**NSLPP MEETING HELD ON 06/04/22****Attachments:**

ADDRESS/WARD: 1B Samora Avenue, Cremorne (C)**APPLICATION No:** D413/21**PROPOSAL:** Alterations and additions to an existing part two/three storey detached dwelling**PLANS REF:**

OWNER: Joseph Hunt & Elizabeth Hunt**APPLICANT:** Neche Page**AUTHOR:** Robin Tse, Senior Assessment Officer**DATE OF REPORT:** 29 March 2022**DATE LODGED:** 29 November 2022**RECOMMENDATION:** Approval

Figure 10: Proposed works and LEP Height Limit

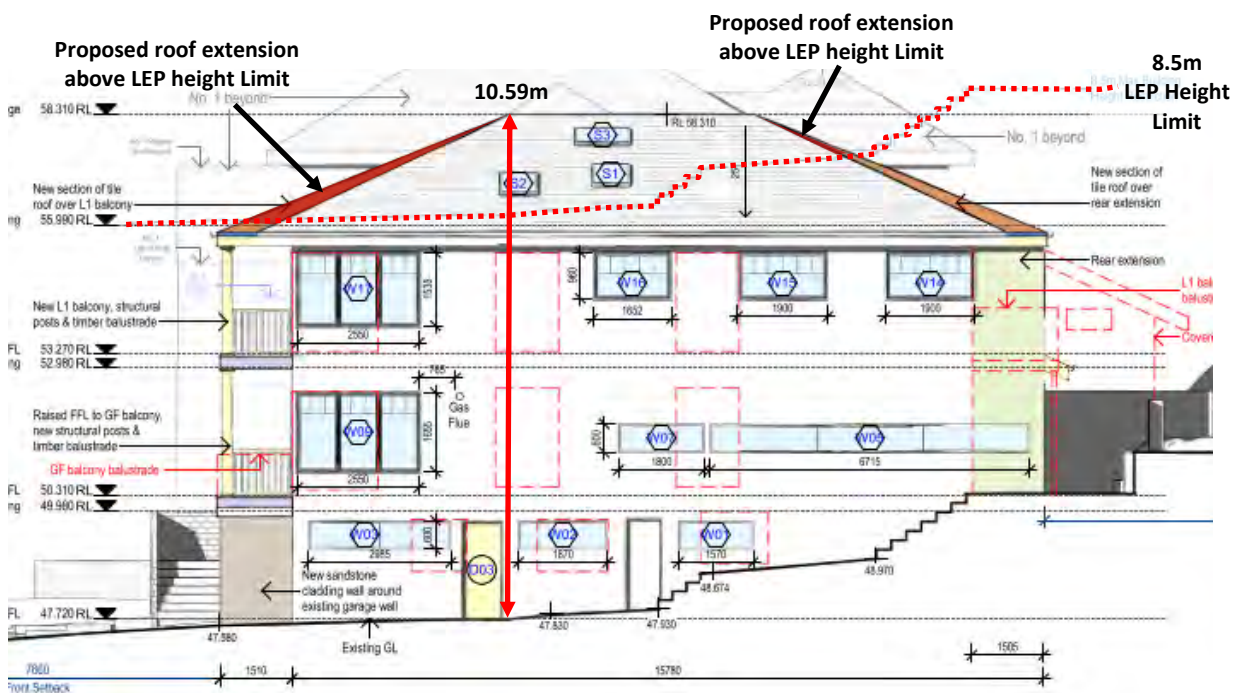
The proposed front balconies and the proposed rear extension at the rear of the existing building would result in a minor extension of the roof. The maximum height of the proposed works would reach 10.59m to match the height of the existing roof ridge. In addition to the roof extension, the proposed skylights would also be located above the 8.5m LEP building height limit as indicated in **Figure 10** below.

The proposal would result in a minor extension of the roof above the LEP height limit on the front and the rear of the existing roof as shown on **Figure 10**. The proposal is unlikely to cause material view loss for the adjoining properties, given that there would be no change to the overall height of the building and a minor increase in the building envelope.

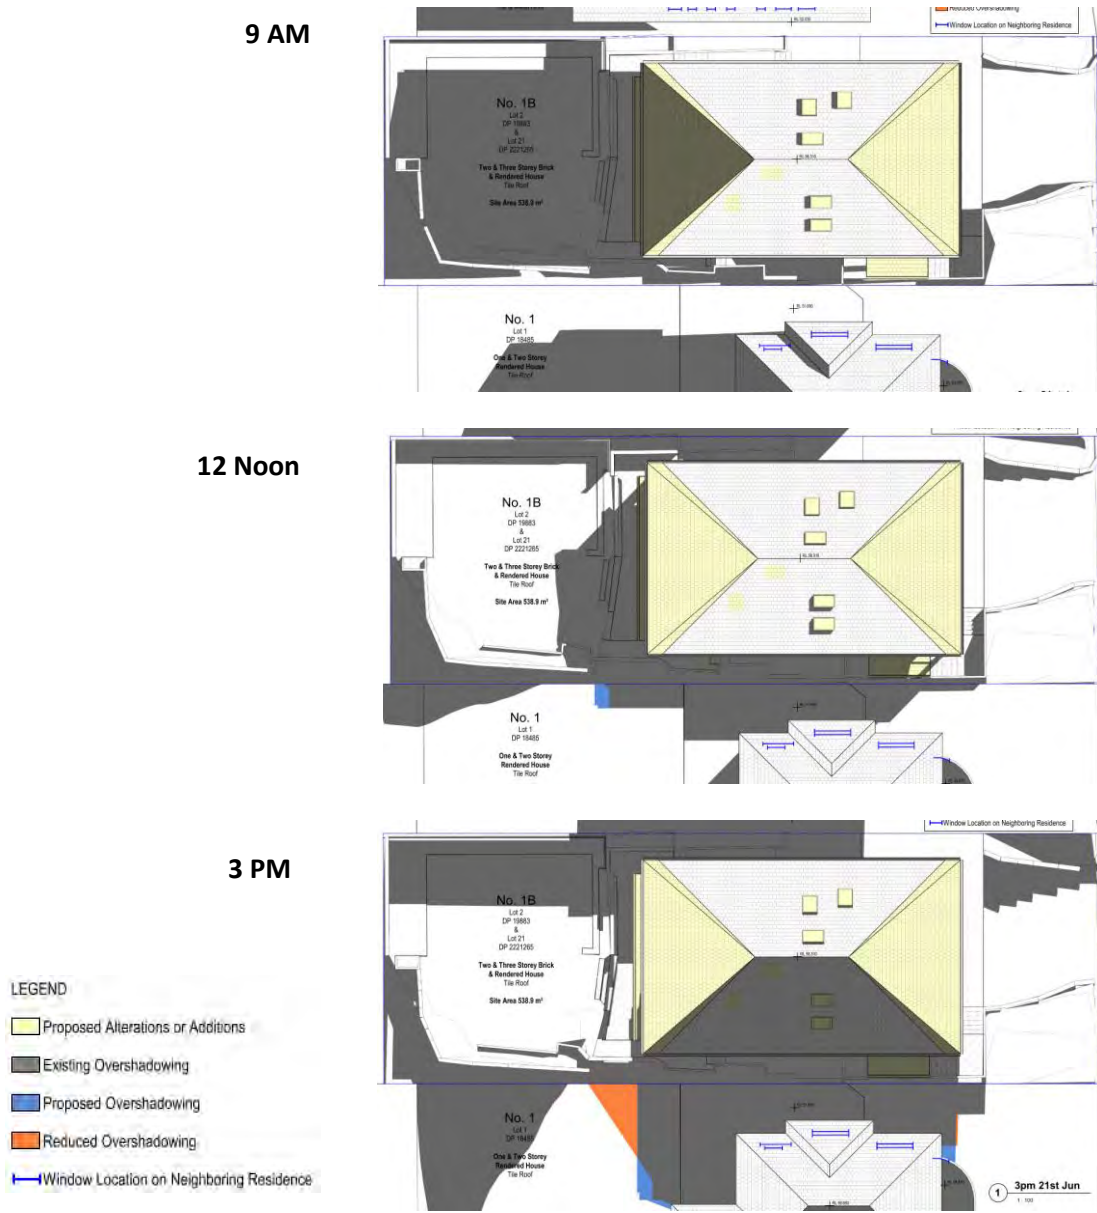
An examination of the shadow diagrams submitted with the application has indicated that the shadows caused by the new building elements would generally affect the adjoining property to the south of the subject site at No.1 Samora Avenue after midday during mid winter (21 June).
